CITY OF ALBUQUERQUE

**Re: Taco Bell Renovations
4815 4th St NW
Grading and Drainage Plan
Engineer's Stamp dated: 8-26-15 (F14D071)**

GRADING AND DRAINAGE PLAN

C-101

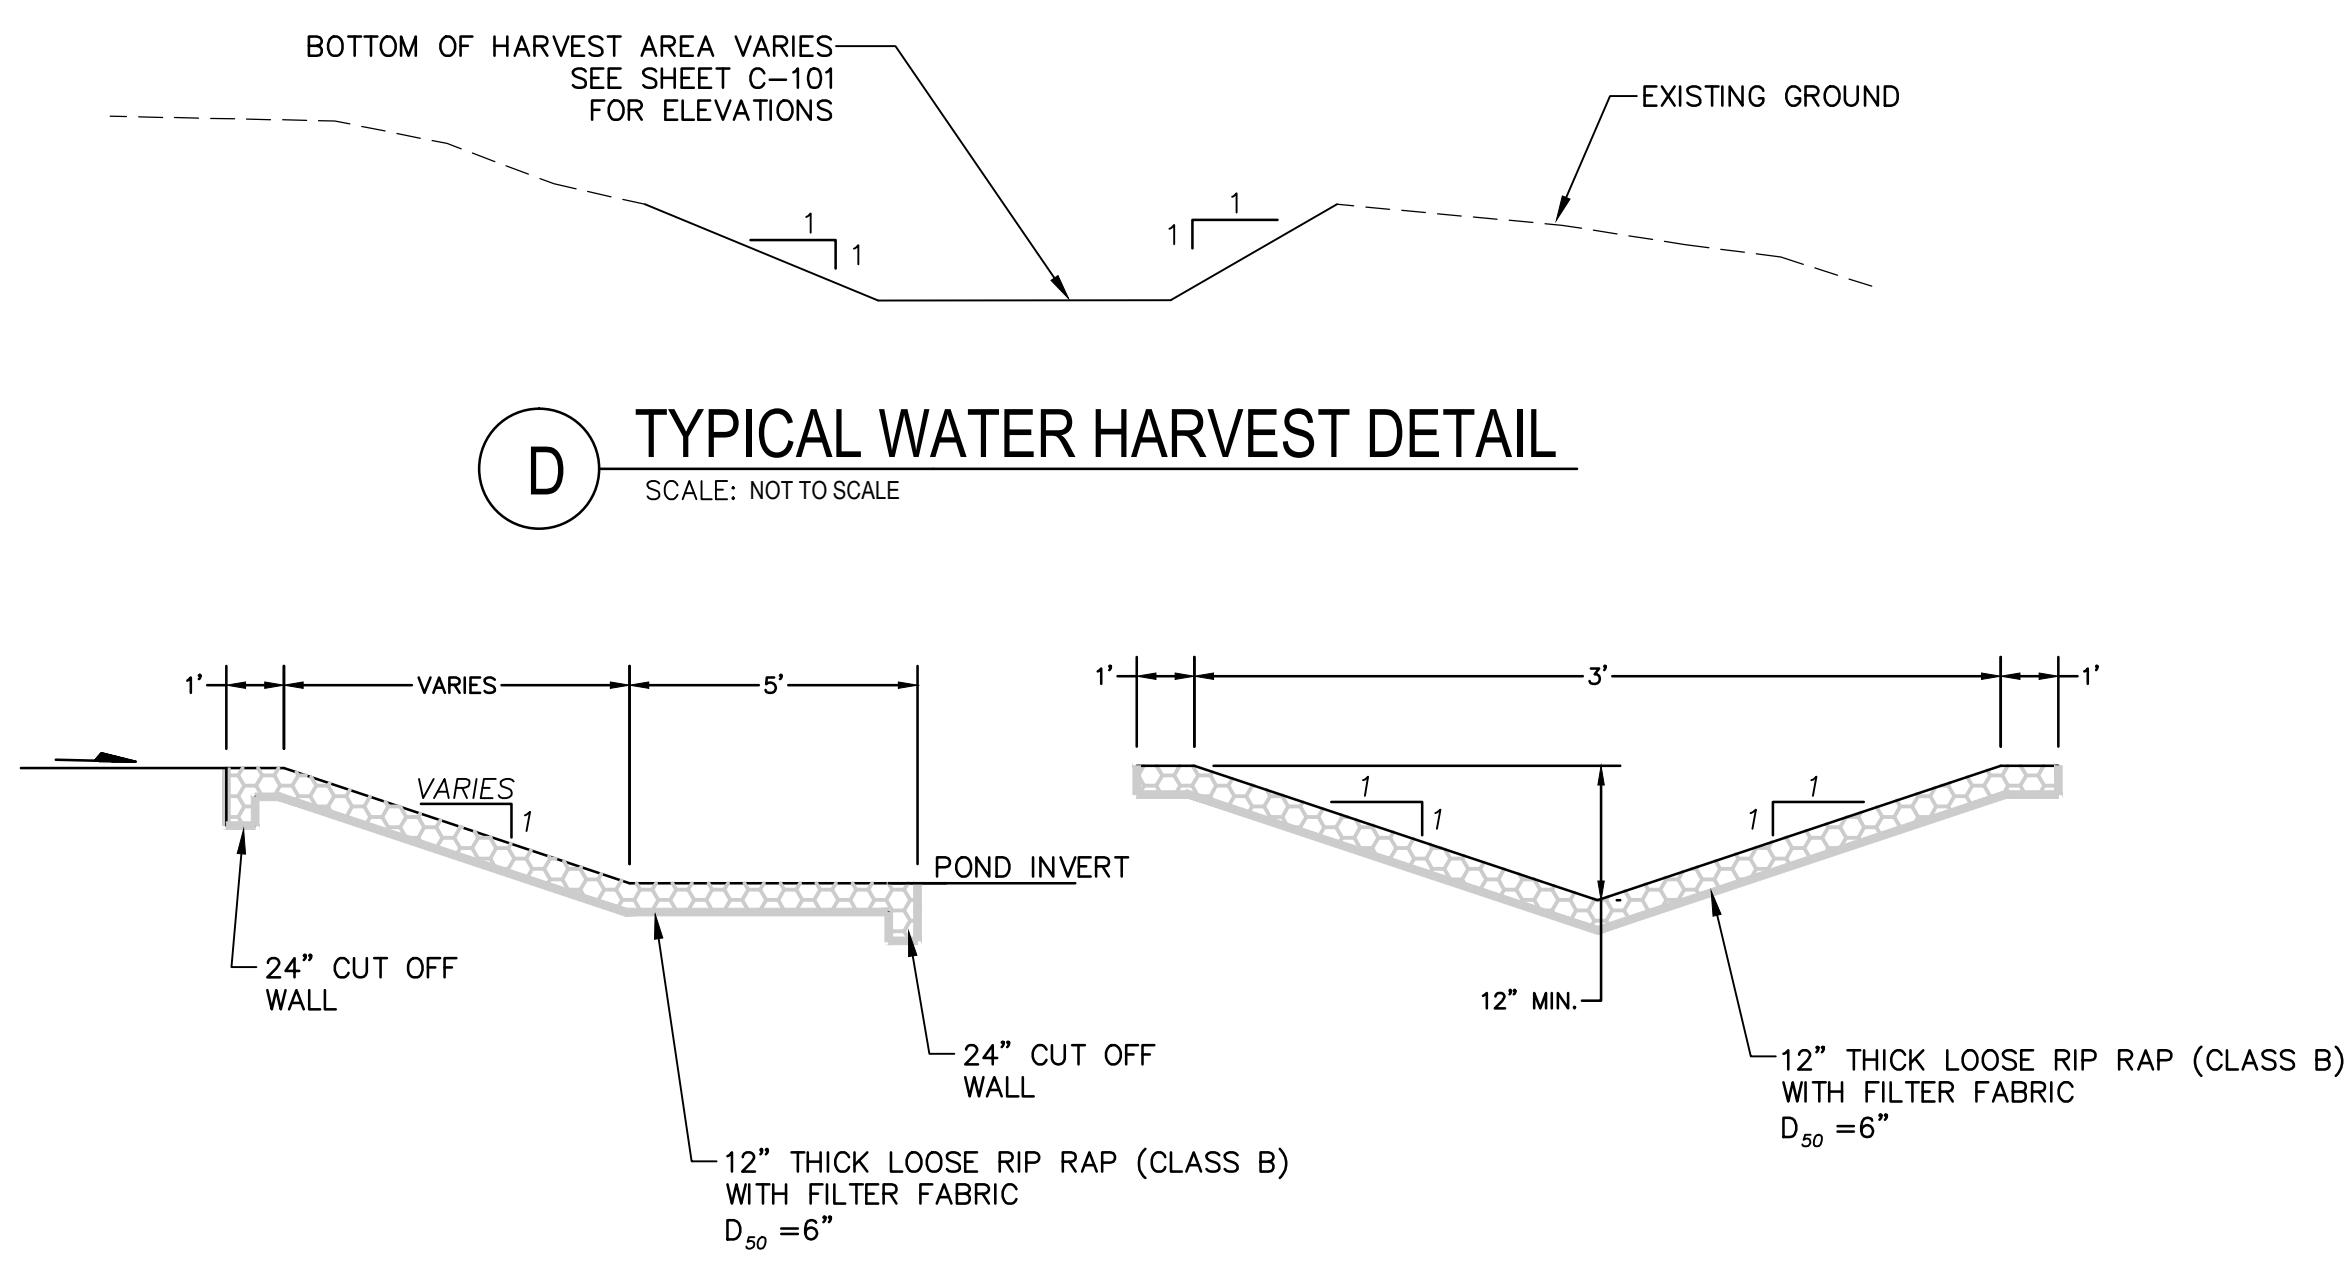
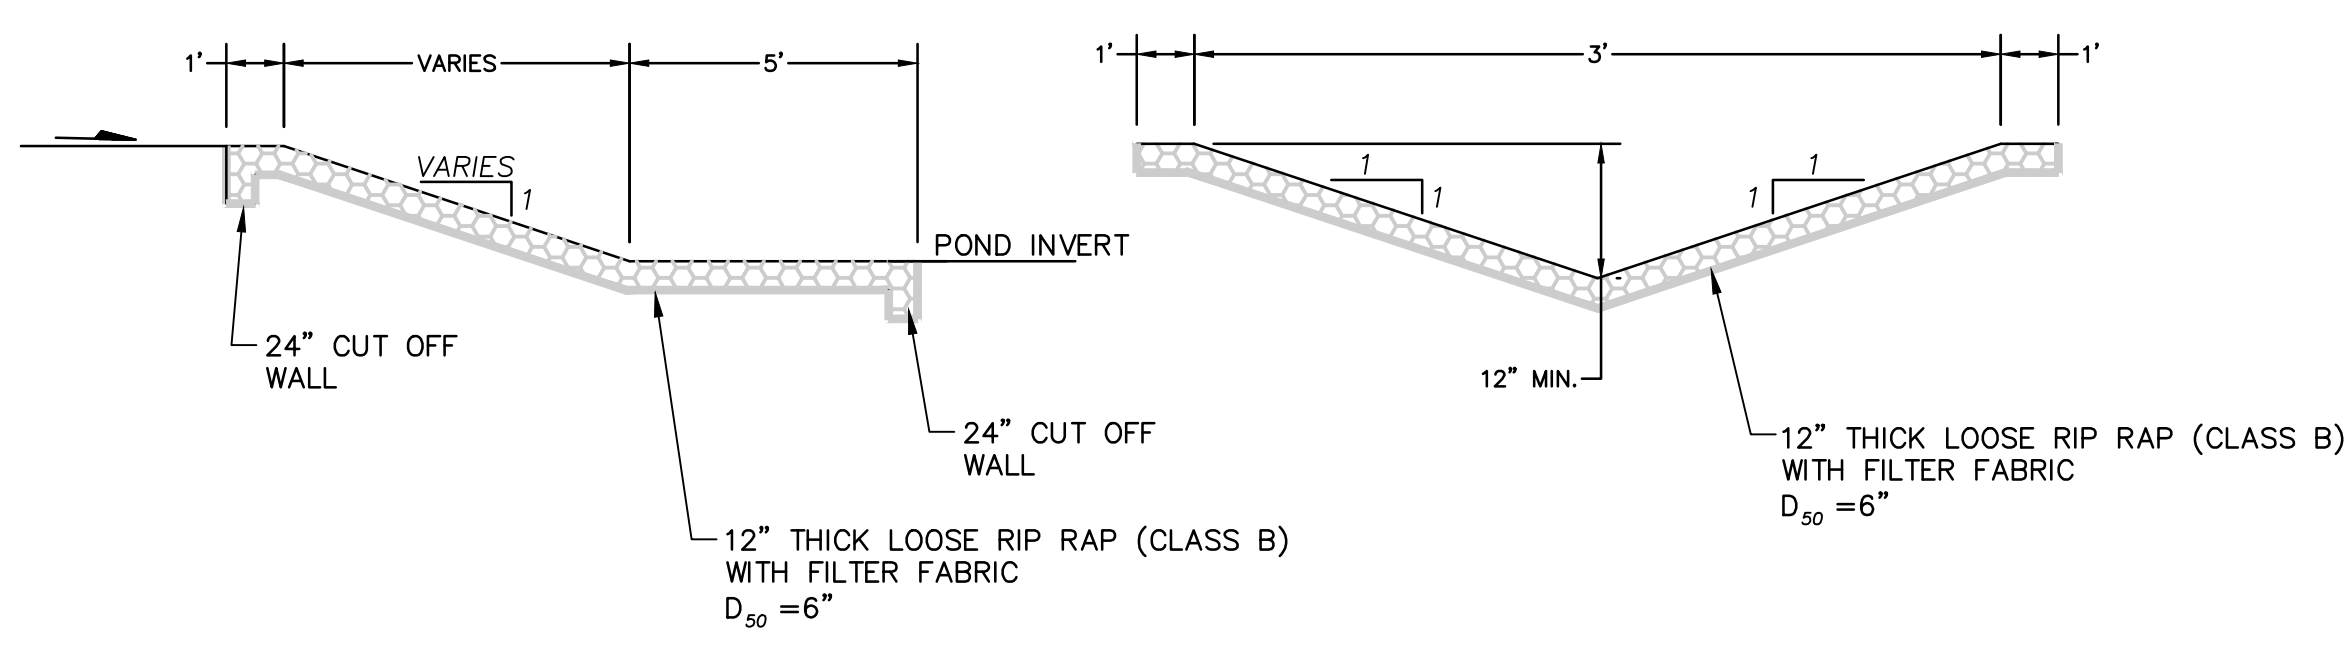
Based upon the information provided in your submittal received 8/26/2015, the above referenced Grading and Drainage Plan is approved for Grading Permit, Building Permit and for SO-19. Contact Jason Rodriguez at 235-8016 to schedule an inspection for the side walk culvert. A separate Excavation/Barricading Permit is required for SO-19 construction within City ROW. A copy of this approval letter must be on hand when applying for the permit.

Prior to Certificate of Occupancy release, approval from Jason Rodriguez for the sidewalk culvert and an Engineer Certification per the DPM checklist will be required.
